FINAL FIELD TASK MODIFICATION REQUEST FOR ADDITIONAL PCB SOURCE
DELINEATION SAMPLING, ROCK CORING AND SEDIMENT TRAP INSTALLATION AT
SOLID WASTE MANAGEMENT UNIT 17 (SWMU 17) PCB CAPACITOR BURIAL POLE YARD
NSA CRANE IN
06/01/2015
TETRA TECH INC

Final Field Task Modification Request for Additional PCB Source Delineation Sampling, Rock Coring, and Sediment Trap Installation at SWMU 17 - PCB Capacitor Burial/Pole Yard

Naval Support Activity Crane, Indiana

Naval Support Activity (NSA) Crane	CTO F270, 112IG05219	NA
Project/Installation Name	CTO and Project Number	Task Mod. Number
QAPP Addendum No. 4 (See Table 1)	SWMU 17	6/1/2015
Modification To (e.g., Work Plan)	Site/Sample Location	Date

CONTRACT NUMBER	F270
APPROVED BY	DATE
APPROVED BY	DATE
FIGURE NO.	2
REV	0

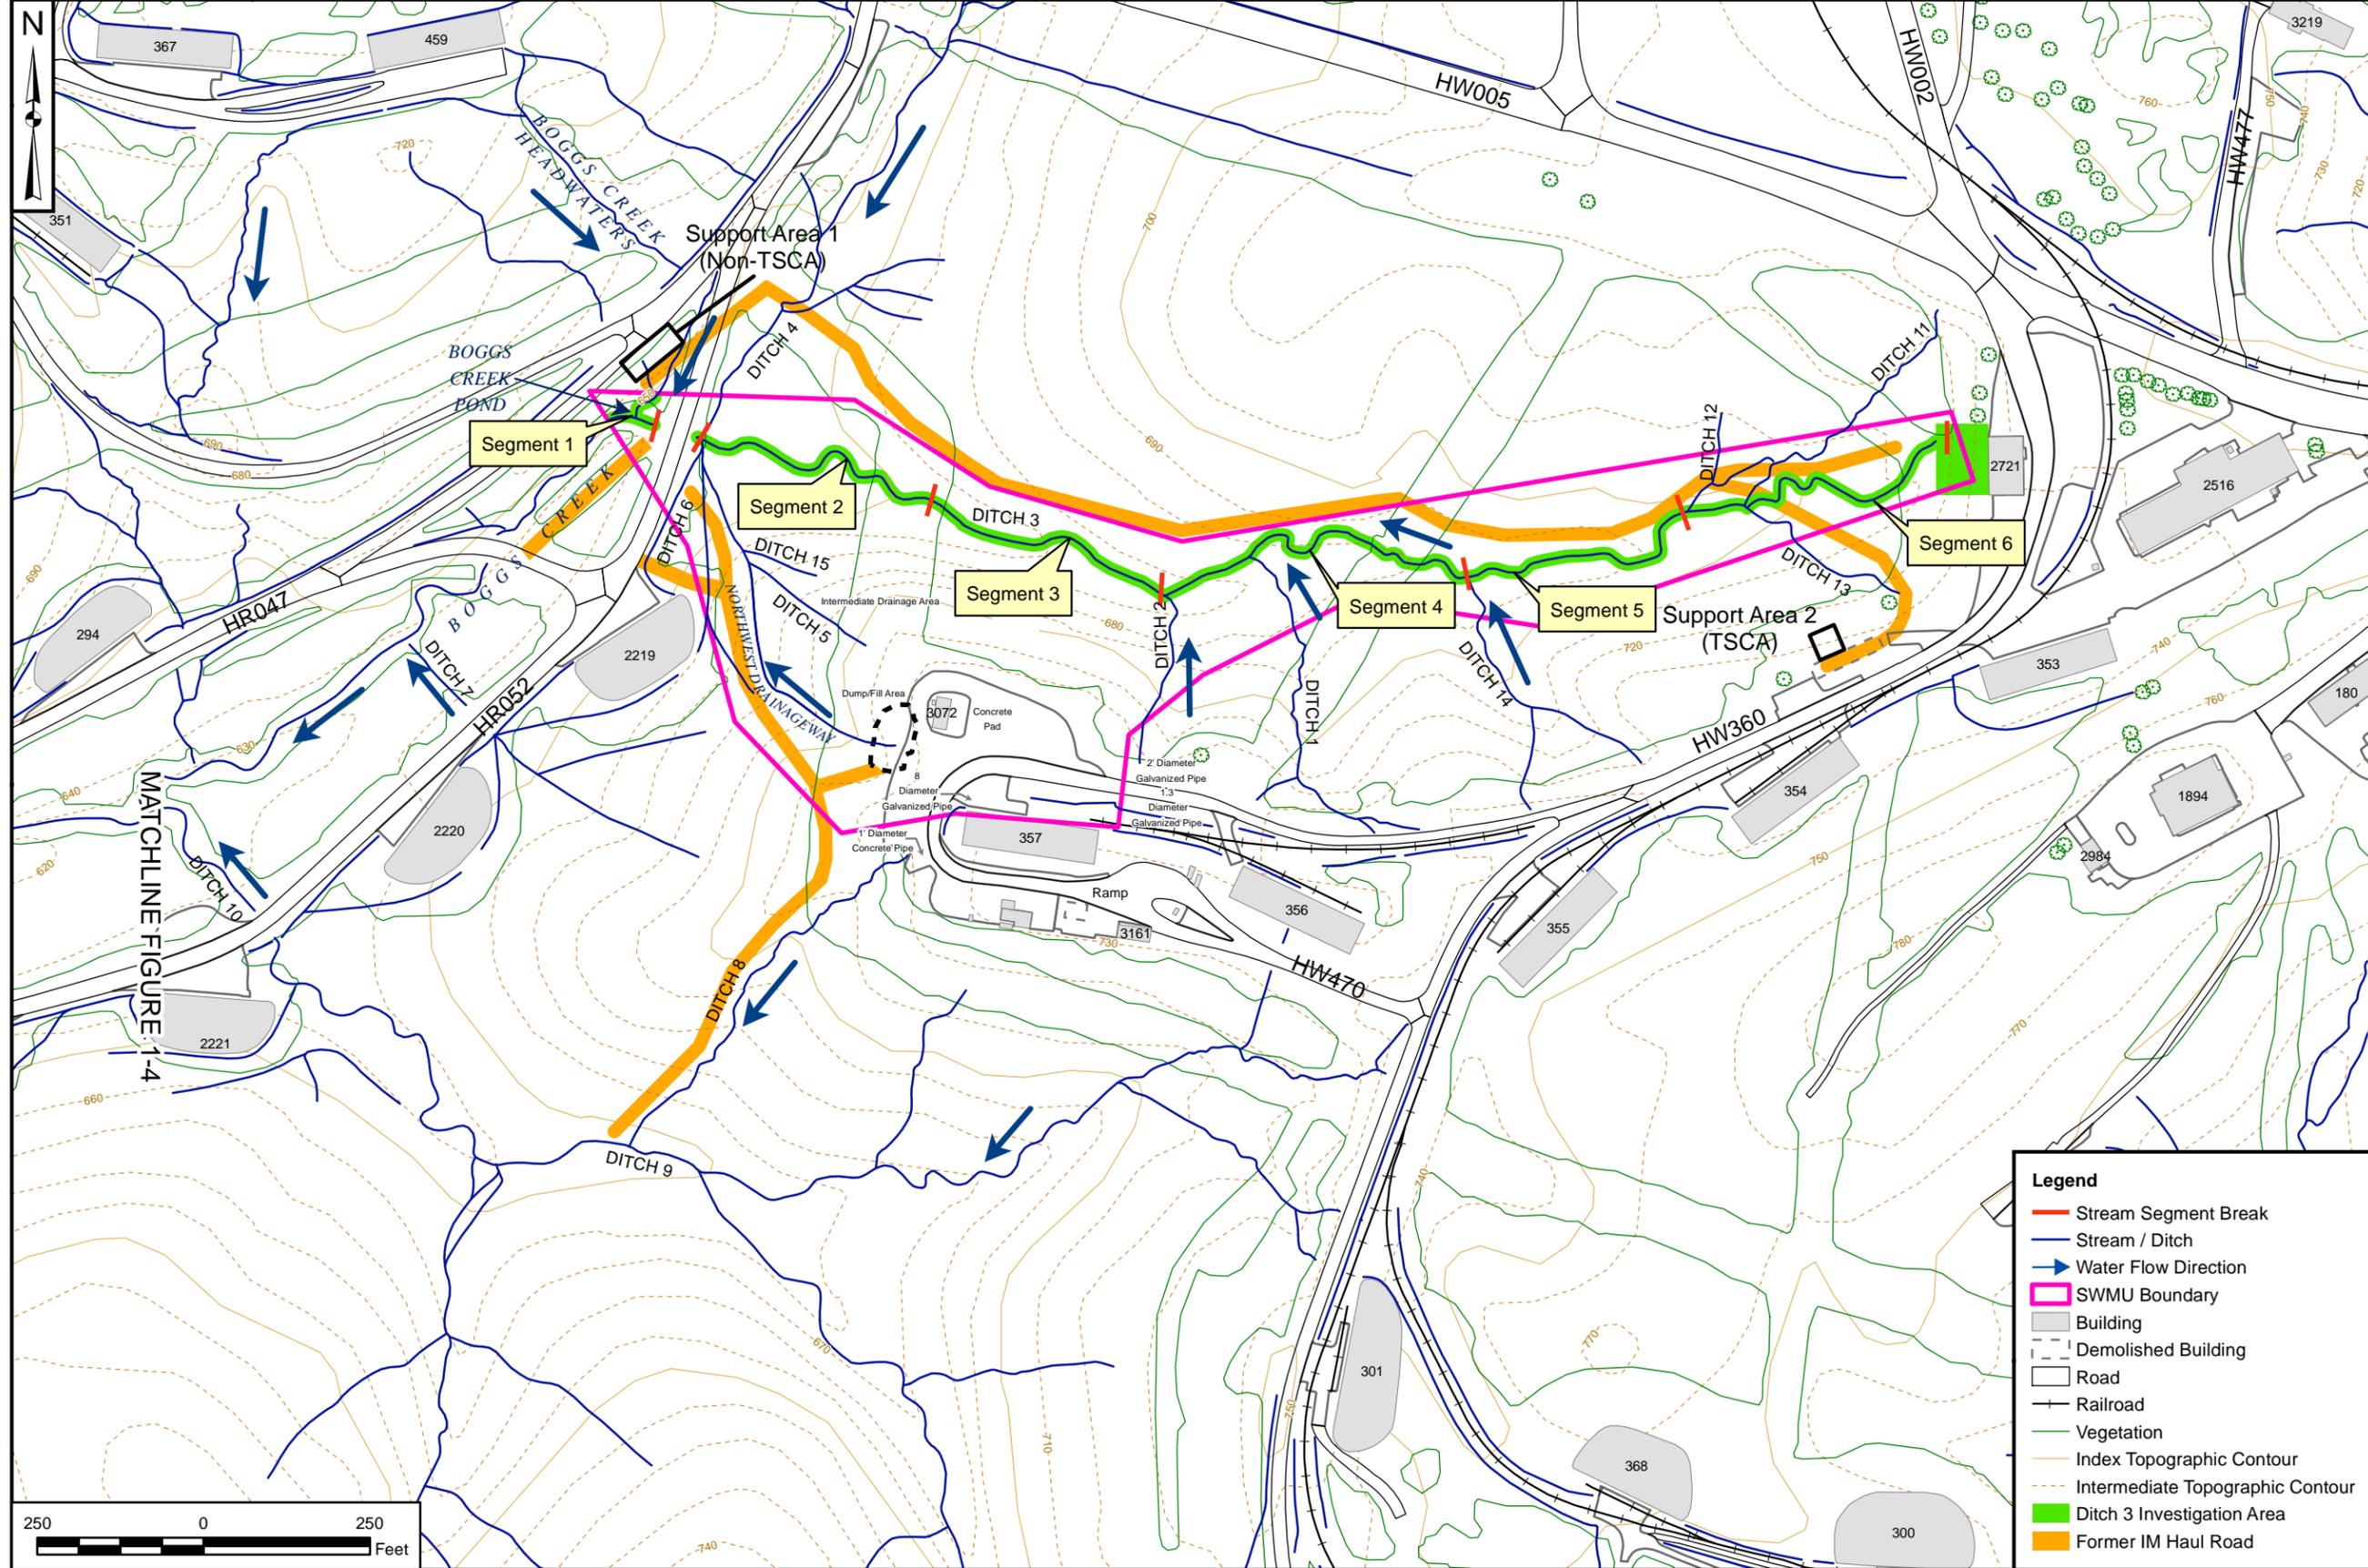
- The southwestern edge of Ditch 3 Segment 1 within Boggs Creek (Figure 6) near previously collected sample 173AWFA1C0006.
- The easternmost area of Ditch 3 Segment 6 near Building 2721 (Figure 2, green-colored rectangle at top of Ditch 3).

Figure 2 shows the area near Building 2721 in which sample collection is planned (green colored rectangle). Table 2 provides an initial list of predetermined sample numbers. This list will be expanded as additional samples are collected.

Figure 2 shows the reach of Ditch 3 to be sampled, i.e., from the top of Ditch 3 to the western edge of Ditch 3 Segment 1. Spacing between sediment samples will be approximately 250 feet from the western edge of Ditch 3 Segment 1 to the eastern edge of Ditch 3 Segment 4. Spacing between sediment samples will be approximately 200 feet from the eastern edge of Ditch 3 Segment 4 to the top of Ditch 3. It may be necessary to relocate samples due to lack of sediment buildup in the planned locations, detection of oily sheens, or other field observations. If a sample is to be relocated, it will be collected in the nearest sediment deposit from the planned location or another location determined to contribute to an overall understanding of the extent of PCB contamination in Ditch 3 sediment. Actual sampling locations will be documented in a summary report at the conclusion of this work. Table 2, which will expand as samples are added, lists the first few planned samples. The last four digits of each sample number indicate the depth in inches. The nominal depth is 0 to 12 inches (last four digits are 0012); ***however, actual depths must be used in the sample numbers.***

CONTRACT NUMBER	CTO NUMBER F271
APPROVED BY	DATE
APPROVED BY	DATE
FIGURE NO. 3	REV 0

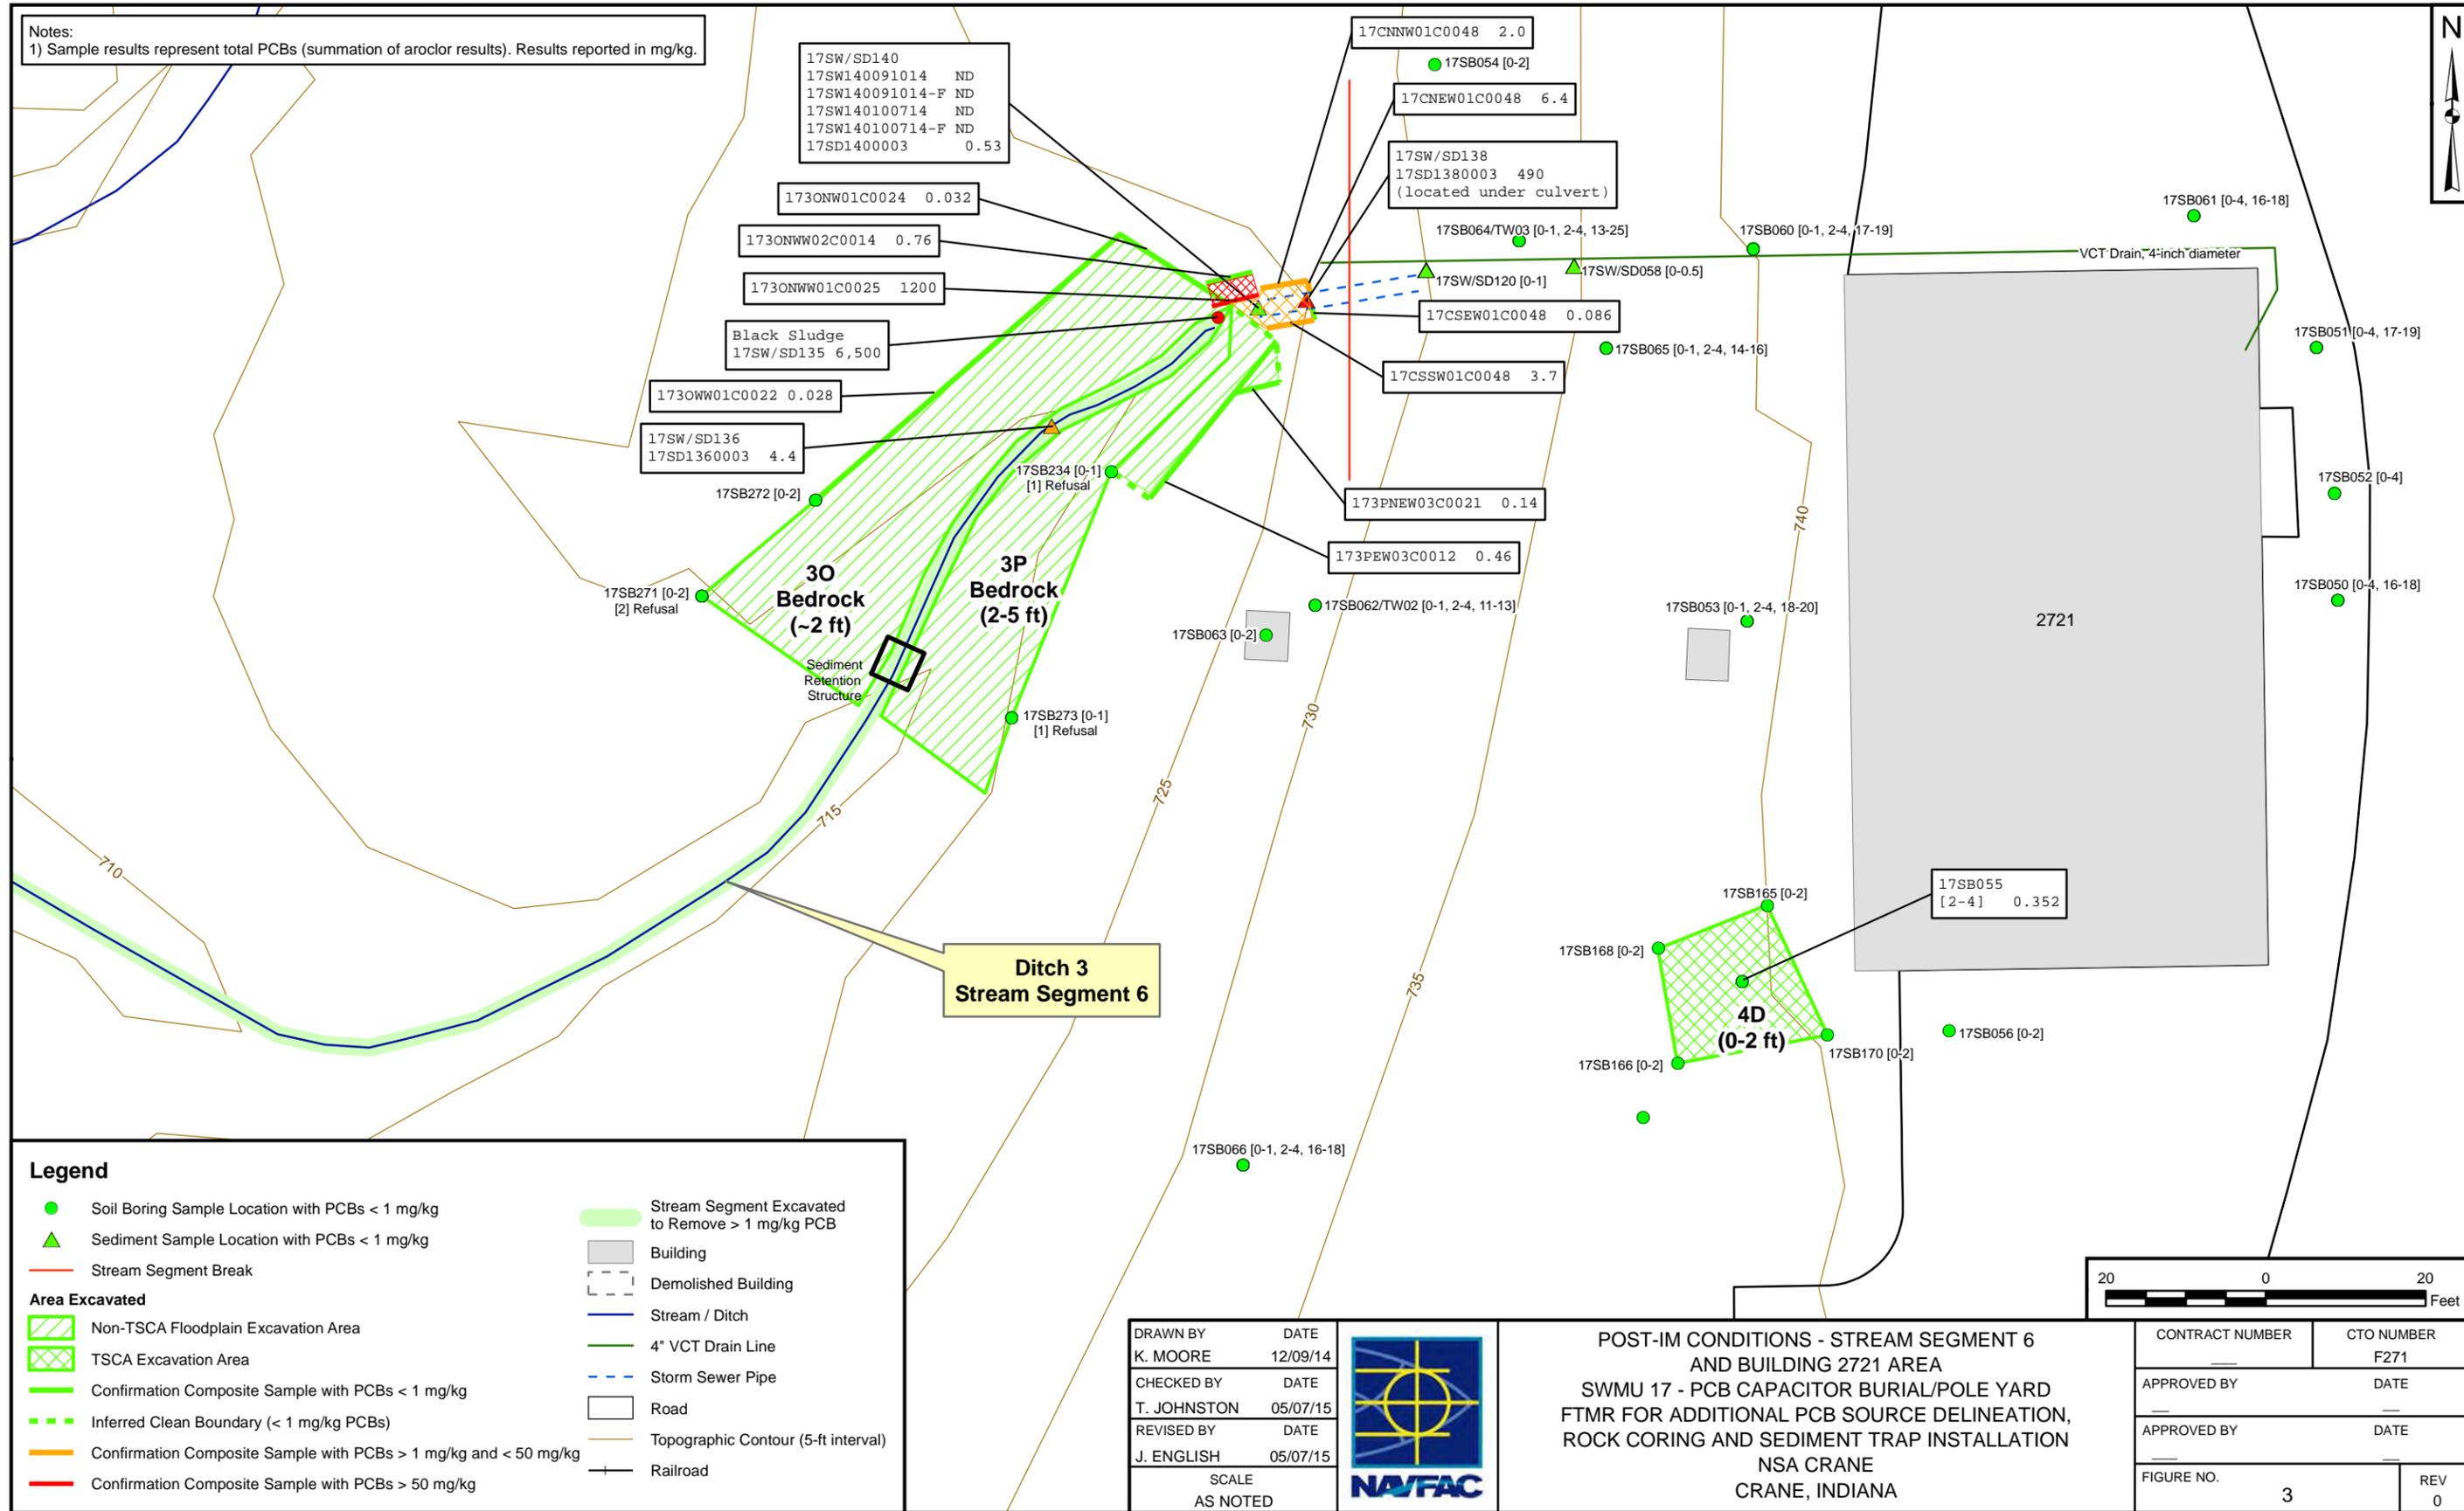
The daylight end of the storm sewer pipe is approximately 80 feet west of Building 2721, as presented on Figure 3. Approximately 15 to 20 feet of the interior sewer pipe can be seen from the daylight end of the pipe. The initial 10 to 12 feet of the storm sewer pipe is a 24-inch cement pipe that then turns slightly to the southeast, and the remainder of the visible pipe is a similar-sized corrugated metal pipe. It is unknown what path the storm sewer pipe takes at that point.

A former 4-inch vitrified clay tile (VCT) floor drain line (VCT pipe) exists at SWMU 17 that may be a continual source of PCB contamination at the site. Figure 3 identifies the presumed location of the VCT pipe, which was historically connected to multiple floor drains within Building 2721. This VCT pipe is believed to discharge on the hillside above the concrete culvert. Floor drains in Building 2721 are currently connected to the NSA Crane sanitary sewer and do not discharge to SWMU 17. However, PCB oil and rinse water may have been washed down the floor drains, and sections of the VCT pipe may have leaked over time before the floor drains were connected to the sanitary sewer. Pockets of PCB oil may exist in the vicinity of the VCT pipe resulting in a continuing source of PCB contamination that has been detected downgradient within the northeastern section of Ditch 3.

The area of the planned trenching study is along the downhill side of the 4-inch VCT pipe shown on Figure 3. A small excavator with an approximately 20-inch-wide bucket will be used for the trenching work at SWMU 17. Because the exact location and depth of the VCT pipe line is unknown, a single north/south trench will initially be dug in the area west of the Building 2721 parking lot located north of the building. Soil will be removed in approximately 1-foot lifts to the top of the pipe. The soil will be segregated alongside the trench according to depth interval and then replaced into the trench in the opposite order that it was removed.

As previously mentioned, up to 10 soil samples from five locations will be collected along the length of the exposed VCT pipe. Figure 3 presents the portion of the pipe from where the samples will be collected. The sample locations will be biased to areas along the VCT pipe that show signs of staining or having a strong organic odor. If no staining or odors are detected, the samples will be collected along each exposed section of trench on the downslope side of the VCT pipe from where it discharges to where it goes under the asphalt at Building 2721.

Figure 3 shows the location of Ditch 3. It is anticipated that coring will be confined to the upper reaches of Ditch 3, i.e., above the confluence of Ditch 3 and Ditch 14. The rock coring will be completed using a gasoline-powered Portable Core Drill with 1.5-inch-diameter bit. The portable drill can be easily transported to the coring location and uses a diamond core bit capable of drilling through bedrock. The drill should allow the cores to be drilled nearly intact, which will allow visual observation of the cores and tracking of core depth.
